LONGVIEW NEIGHBOURHOOD 7 LRD

2326 - 700, Rev H
Ballyvolane, Cork
-May 2026

ARCHITECT'S DESIGN STATEMENT

32B – Placemaking, Overall Design & Layout – 19.03.2026

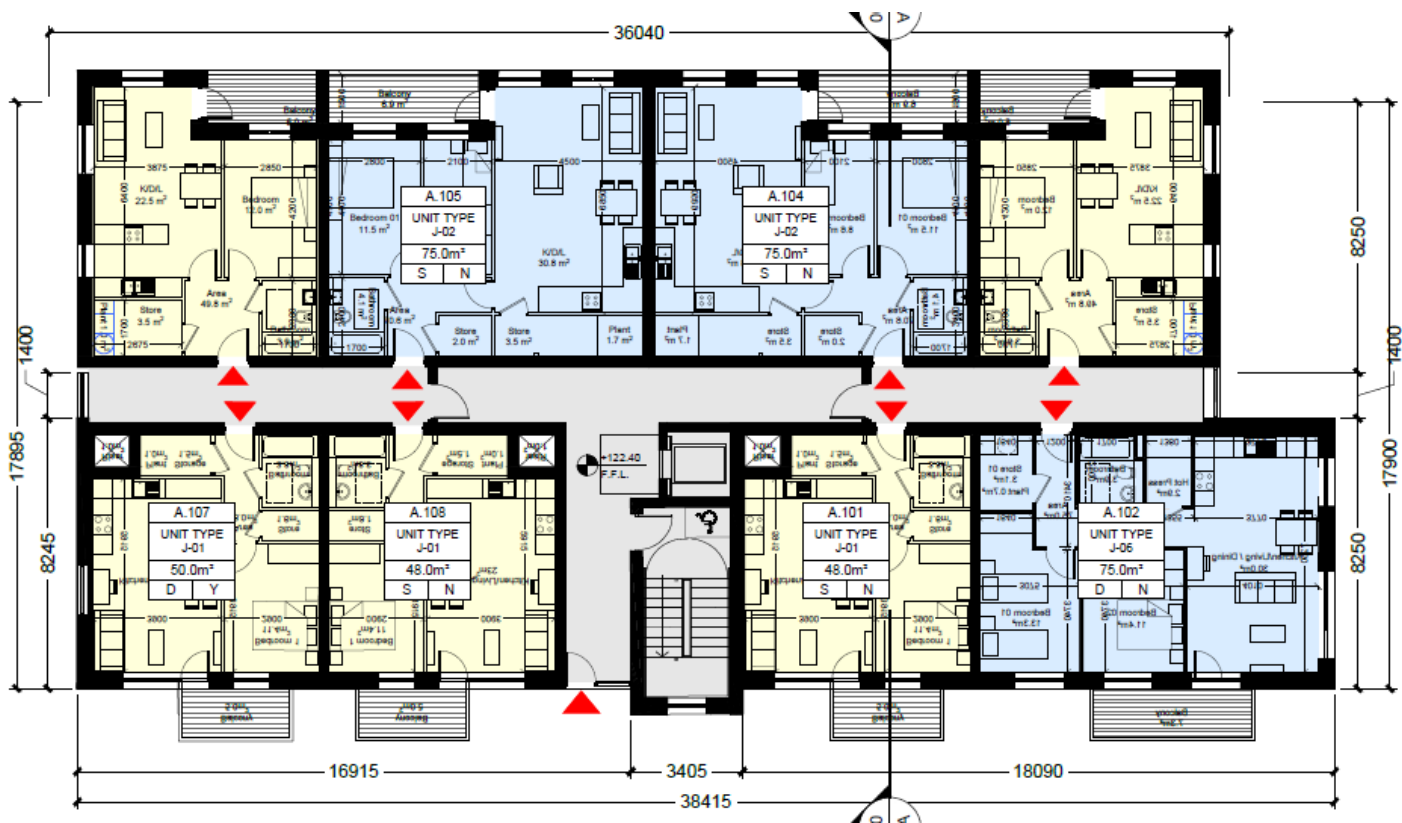
b) Block Layout within the Scheme
The block layout is regular, and orthogonal as far as site constraints permit. This provides a legible structure and a sense of enclosure and place within the development, in line with DMURS and DMQH, and is supported. There is active frontage onto the majority of open space perimeters. Where continuous active frontage is not provided, for example gable ends fronting onto public realm, windows should be positioned to provide passive supervision. • We would recommend enhancing the proposed Green-blue infrastructure by introducing NbS, for example trees, swales, and linear raingardens, along north-south roads between blocks to the south of the Central Square.

Please see attached response document(s) by Wilson Architecture.
House types with relatively blank gables have been revised to include more windows to provide more passive supervision. Each “block” of houses now has a unit on the corner which has windows looking in two directions enhancing passive observation of spaces.

d) Duplex Blocks C & D – Aspect, Ground Level & Northern Square

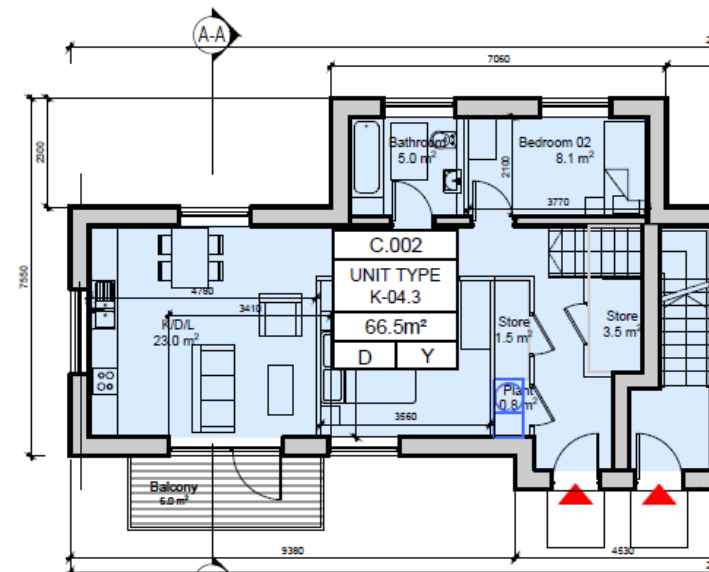
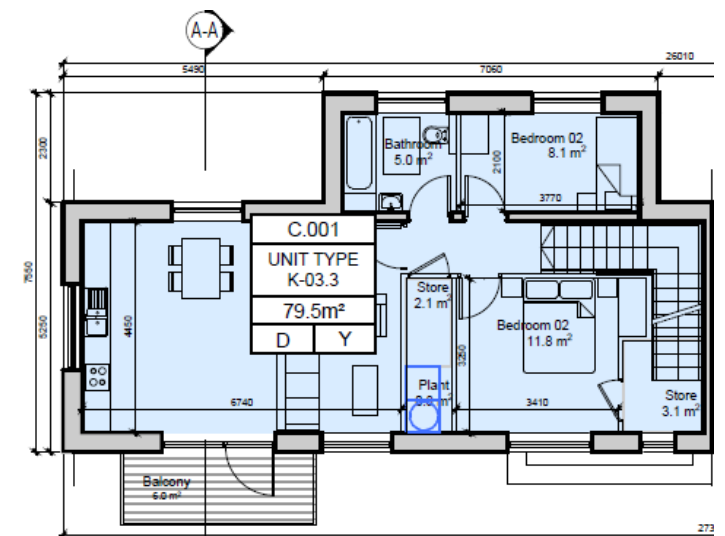
- Current layouts have mainly north-facing living spaces. Raising the entrance floor level to provide level access entrance to the ground floor from the south, with introduction of a retaining embankment to the north, would provide a two-storey facade onto the North Square, and create truly dual-aspect units, improving sunlight access in line with DMQH guidance on dwelling quality and aspect/daylight. The resulting retaining embankment to the north could be planted with native species.

- The blocks would benefit from reorganisation of interior layouts: stairs and service spaces currently occupy much of the south elevation, while living spaces would get more benefit from the southerly aspect. Window composition facing south onto the North Square could be reorganised accordingly, generating a more ordered elevation and better activation of the courtyard elevation/passive surveillance.

Blocks C & D have been revised to have living spaces which are orientated both north and south, improving the residents access to natural light and also providing more passive supervision to the northern square and distributor road. The balconies have been moved to the southern side to improve their aspect. The entrances to ground and first floor duplexes are both now set at ground floor, this will require building up from the road level to negotiate the level change, the resulting embankment will be softened with planting. Stairs and service areas have been concentrated along the party wall of each duplex unit. This has freed up the layout to allow for living spaces to take advantage of the southern aspect of these blocks. The regularised entry level has allowed the facades to be rationalised with full scale elevations along the northern edge of the square. The entrances to all duplexes will help to activate this public space.
